Appendix B

Road Safety Review Photo Log

Prepared by: TranSystems

Field Visit Date: April 9, 2019

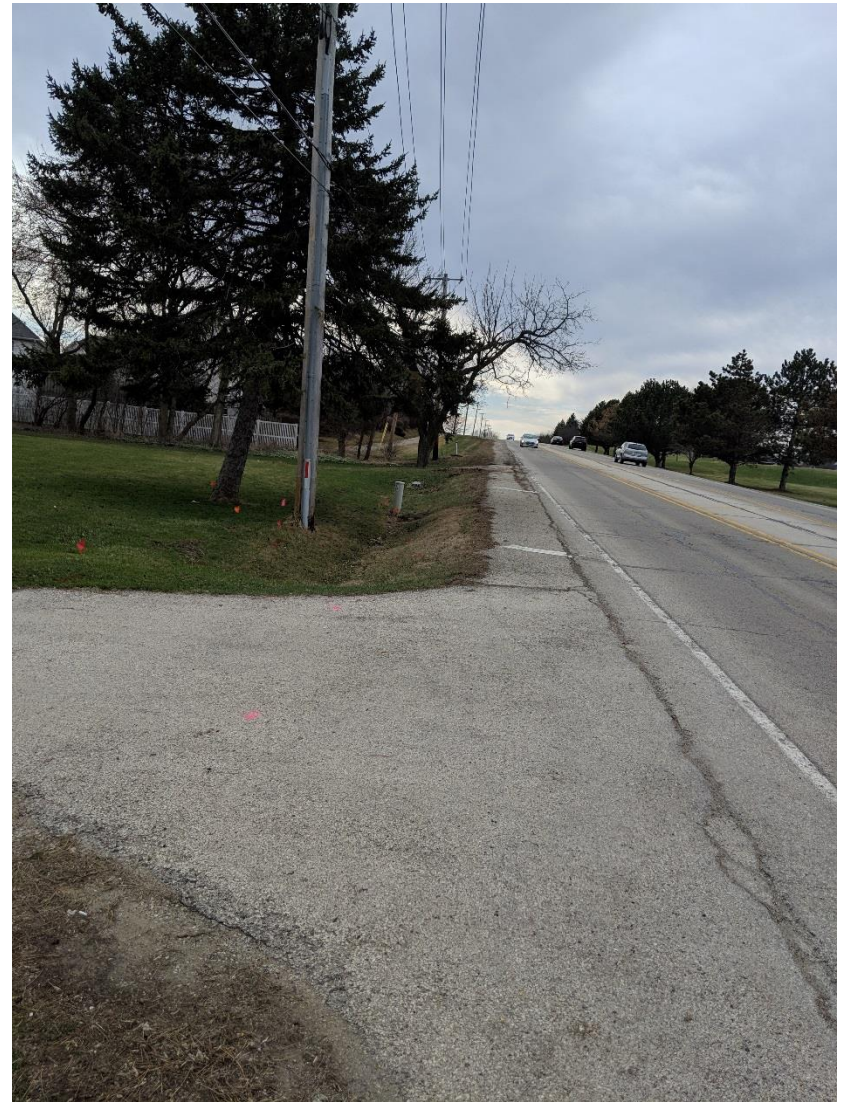
Haligus Rd & Ackman Rd, SE Corner
Critical foreslope and unfavorable ditch section

Lakewood Rd & Ackman Rd, SE Corner
Utility pole guy wire in clear zone

Ronan Ct & Ackman Rd
No crosswalk pavement markings, worn ADA tiles (TYP)

Ackman Rd, between Albrecht Rd & Redtail Dr
Critical/Non-Recoverable foreslope potentially extends clear zone to hazards (utility poles, trees)

Ackman Rd, between Albrecht Rd & Redtail Dr
Damaged EOP

Ackman Rd, between Albrecht Rd & Redtail Dr
Non-traversable culvert end section with steep grades and eroded ground

Ackman Rd, between Albrecht Rd & Redtail Dr
Non-traversable culvert end section with steep grades and eroded ground

Redtail Dr & Ackman Rd
Edge of pavement damaged at corner radii

Redtail Dr & Ackman Rd
Edge of pavement damaged at corner radii

Redtail Dr & Ackman Rd
Edge of pavement damaged

Ackman Rd, between Redtail Dr & Swanson Rd
Guardrail limits do not cover length of need for culvert and foreslope hazards.

Ackman Rd, between Redtail Dr & Swanson Rd
Terminals do not meet current standards.

Ackman Rd, between Redtail Dr & Swanson Rd
Non-recoverable, unprotected foreslope on approach to culvert hazard

Ackman Rd, between Redtail Dr & Swanson Rd
Non-recoverable, unprotected foreslope adjacent to culvert hazard

Ackman Rd, between Swanson Rd & Huntley Rd (and other locations)
Undersized grate on culvert end section

Huntley Rd & Ackman Rd
Edge of pavement damaged at corner radii

Huntley Rd & Ackman Rd
Edge of pavement damaged at corner radii

Huntley Rd & Ackman Rd
Off-road tire marks observed, starting at approximately 30 ft east of the intersection of Huntley Rd & Ackman Rd . Possibly from loss of control during a southbound left-turn maneuver.

Ackman Rd, between Huntley Rd & Amberwood Rd
Non-traversable culvert end section in clear zone

Amberwood Rd & Ackman Rd
Edge of pavement damaged at corner radii

Ackman Rd, between Huntley Rd & Amberwood Rd

Steep foreslope and abrupt grading around drainage structure not flush with adjacent ground

Golf Course Rd & Ackman Rd

Intersection pavement in poor condition (pot holes, depressions and pavement cracking)

Golf Course Rd & Ackman Rd

Intersection pavement in poor condition (pot holes, depressions and pavement cracking)

Golf Course Rd & Ackman Rd

Edge of pavement damaged at corner radii and Intersection pavement in poor condition (pot holes, depressions and pavement cracking)

Golf Course Rd & Ackman Rd

Edge of pavement damaged at corner radii and Intersection pavement in poor condition (pot holes, depressions and pavement cracking)

Golf Course Rd & Ackman Rd

Excessive glare and poor signal visibility during sunrise and sunset

Golf Course Rd & Ackman Rd
Non-functional push button in SW corner

Golf Course Rd & Ackman Rd
ADA ramp tiles located within pavement limits in NW corner

Golf Course Rd & Ackman Rd
Non-traversable culvert end section in clear zone

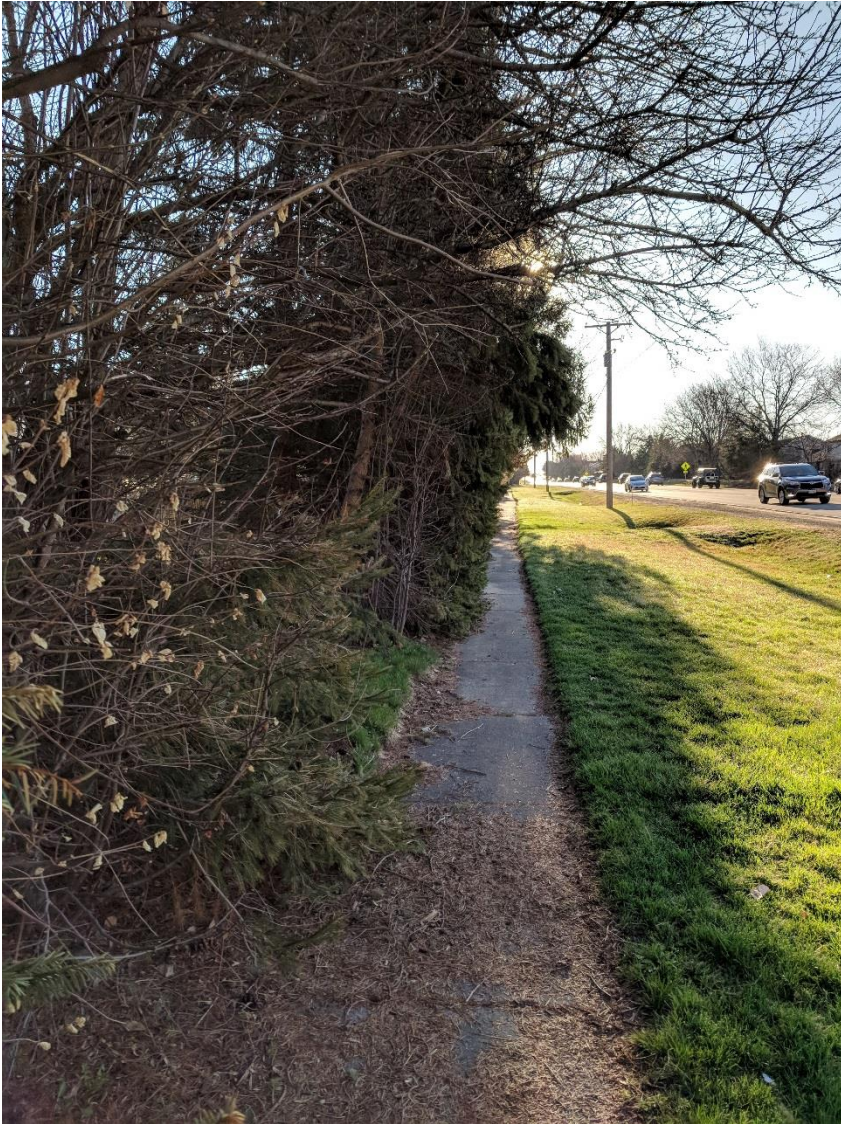
Golf Course Rd & Ackman Rd
Utility pole and non-traversable culvert end section potentially within clear zone

Ackman Rd, between Golf Course Rd & Westport Ridge
Utility pole and non-traversable culvert end section potentially within clear zone

Ackman Rd, between Golf Course Rd & Westport Ridge
Bike Connectivity: Multiuse path terminates to sidewalk on midblock, short of bike lanes on Golf Course Rd

Ackman Rd, between Golf Course Rd & Westport Ridge
Overgrown vegetation encroaches on sidewalk, ADA compliant width not available

Ackman Rd, between Golf Course Rd & Westport Ridge
Non-traversable culvert end section in clear zone (remove obsolete driveway)

Ackman Rd, between Golf Course Rd & Westport Ridge
Non-traversable culvert end section in clear zone (remove obsolete driveway)

Westport Ridge & Ackman Rd
Excessive glare observed during sunrise and sunset hours at mid-block crossing equipped with rectangular rapid-flashing beacon, limiting the visibility of the signs and flashing beacons.

Ackman Rd, between Westport Ridge & Crimson Dr
Non-recoverable foreslope adjacent to multi-use path

Ackman Rd, between Westport Ridge & Crimson Dr
Non-traversable drainage structure in clear zone

Ackman Rd, between Westport Ridge & Crimson Dr
Non-traversable culvert end section in clear zone

Crimson Dr & Ackman Rd
Non-breakaway light pole in clear zone

Crimson Dr & Ackman Rd
Broken curb at NW corner radius

Ackman Rd, between Skyridge Dr and Randall Rd
Remove incorrect application of lane drop (W4-2) sign
